Vieux Carré Commission Architecture Committee Meeting

Tuesday, August 27, 2024

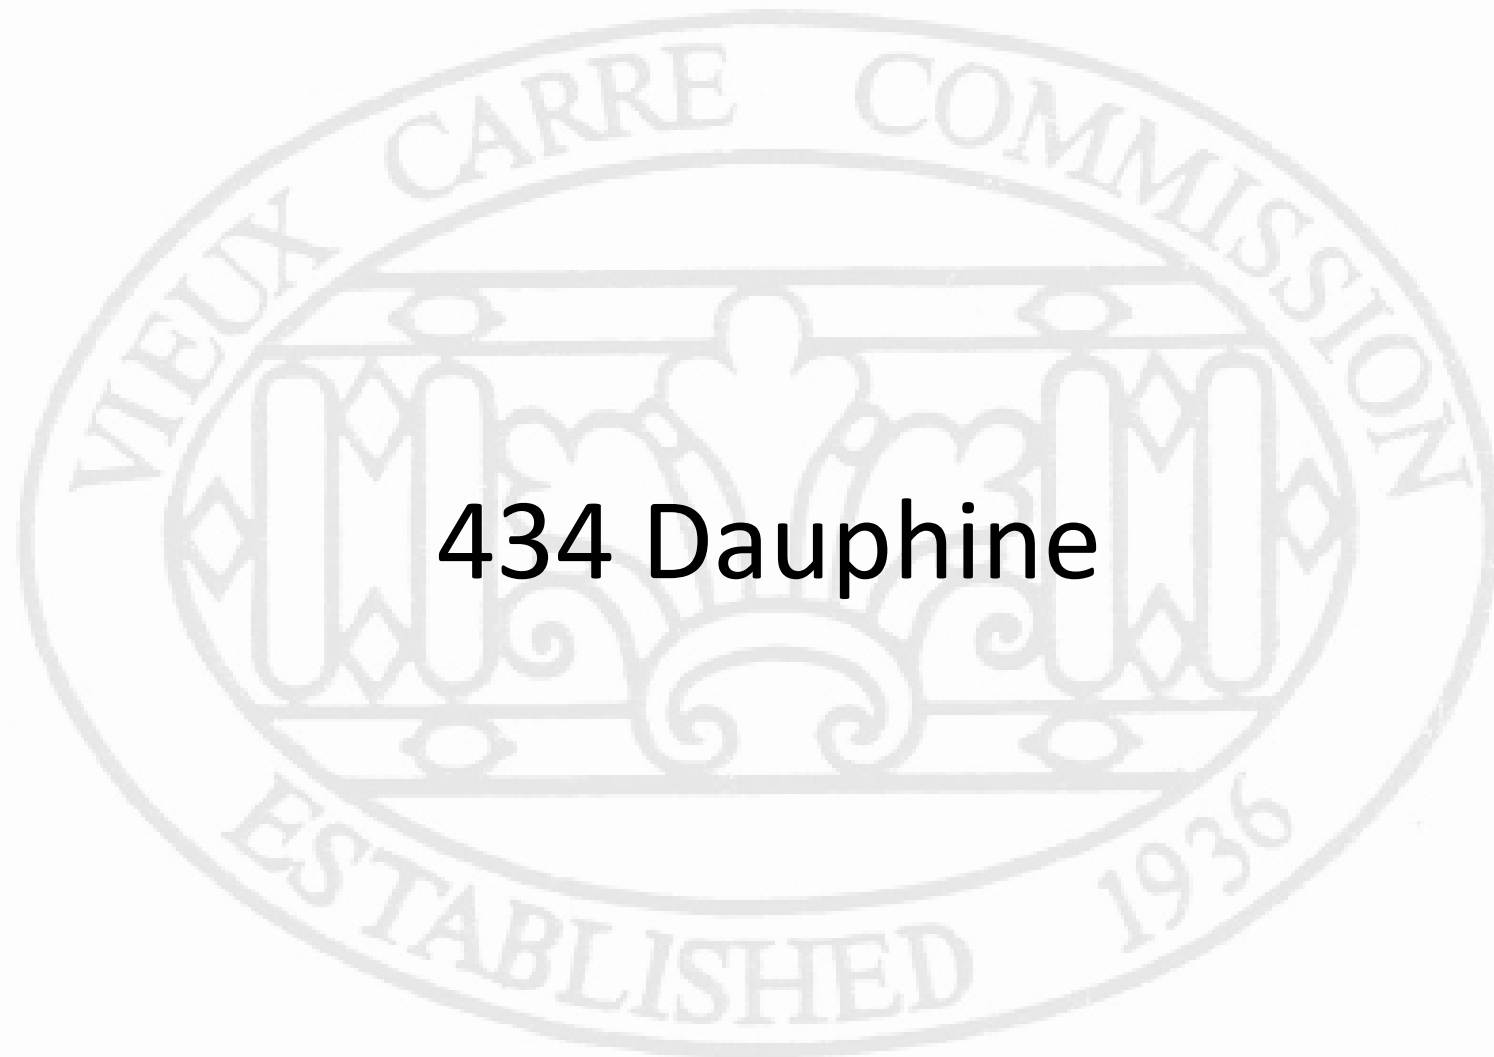
Multiple references are made to a roofing inspection report that was not included in the submittal. The rear 3/12 slope roof will have its slate removed, to be replaced with an unspecified standing seam metal. More information is needed, but slate should not have been used on a roof with this low of a slope in the first place, so this will likely be conceptually approvable.
